Subject: 10 CFR Part 21 report concerning 3" and 4" Borg Warner Check Valves

Reference: NRC Part 21 Report 2001-27-0

Subject: 10 CFR Part 21 report concerning Borg Warner 3" & 4" Swing Check Valves

Figure 1 - Design History

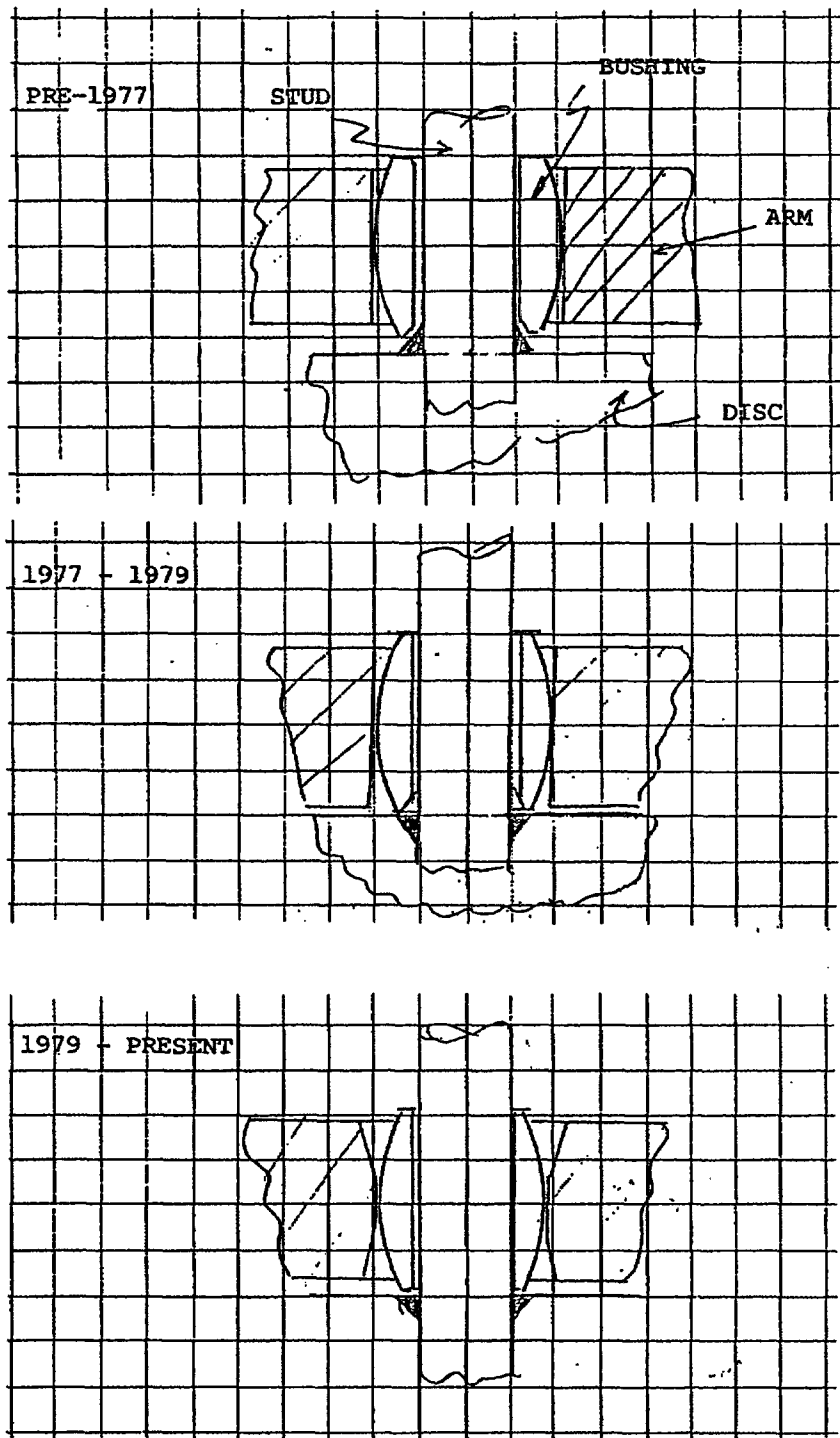
During the Part 21 investigation regarding the stud failure, Flowserve reviewed the history of the disc assembly drawing and discovered that the weld configuration was not modified to provide a surface flat and flush with the back face of the disc until 1990. This finding is inconsistent with the information provided in the 10CFR Part 21 report issued by Flowserve – Williamsport in August of 2001.

The only known design with this condition is disc assembly drawing number 76333, which is identified as the disc and stud assembly part number on the Borg Warner valve assembly drawing. Flowserve has no reason to believe that the number of disc assemblies with raised welds produced after 1977 is extensive. However, knowing that there was one with this condition, Flowserve decided it would be prudent to re-notify all utilities originally notified in 2001.

Flowserve recommends that 3" and 4" Borg Warner swing check valves and spare part disc assemblies provided after 1977 be inspected for this condition at the earliest convenience.

A review of the assembly drawings for 3"-300 Borg Warner check valves currently in-service may be conducted to identify any with disc and stud assembly part number 76333. Those provided in 1990 or earlier may not have the modified design.

10 CFR, Part 21, Notification
(Ref. No. CFRN-9301)

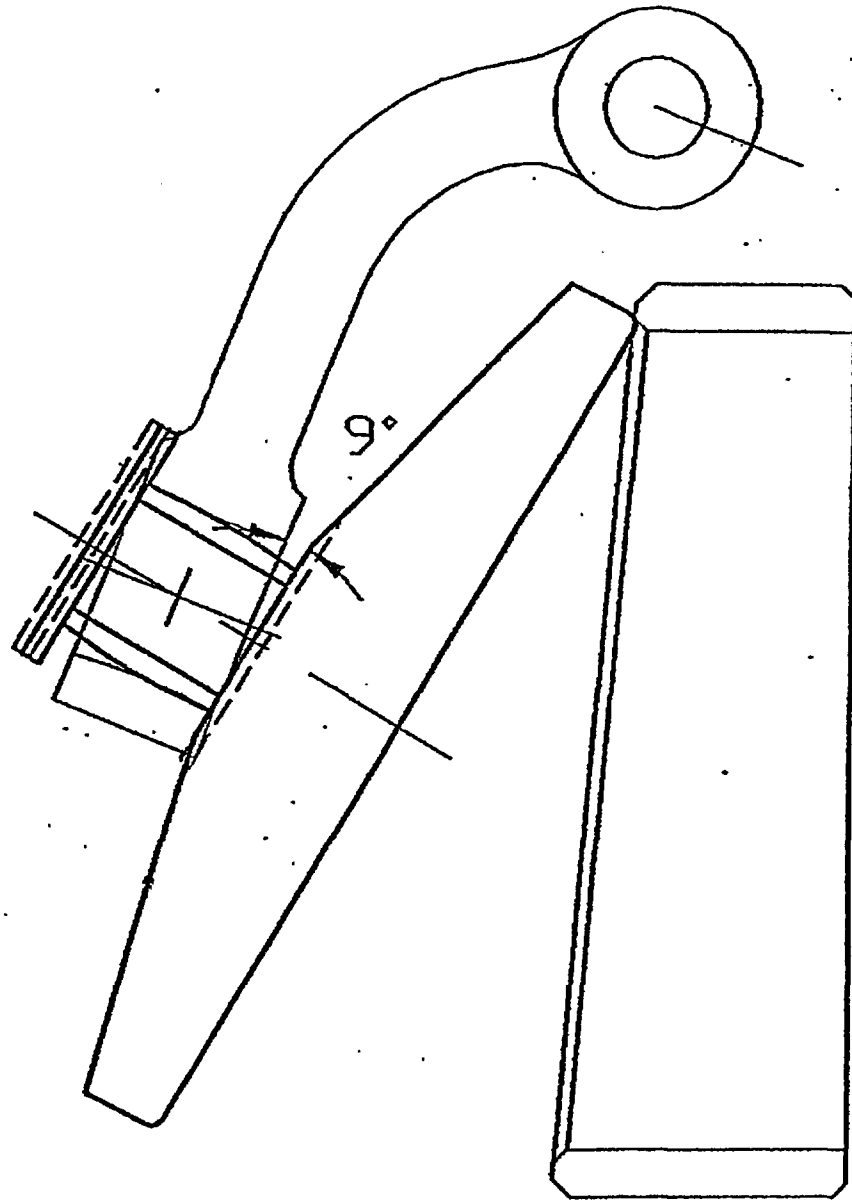
Valve 2CC-0697 did not fully close during pre-operational testing. Radiographs taken at the time of failure show the disk positioned at approximately 21° from the full closed position. The valve was disassembled. The top of the disk was found to be lodged under the seat lip preventing full closure. Valve 2CC-0693 subsequently failed testing in a similar manner. Both valves are located in the Component Cooling Water return lines from the Reactor Coolant Pump Motor Coolers and do not serve an active safety function. However the failure mechanism could apply to other valves that do provide a safety function.

This notice applies to all BW/IP 4-inch, 150#, bolted bonnet swing check valves which have a raised disk-stud retention weld on the back surface of the disk.

Corrective action is complete with the disk design modification identified above.
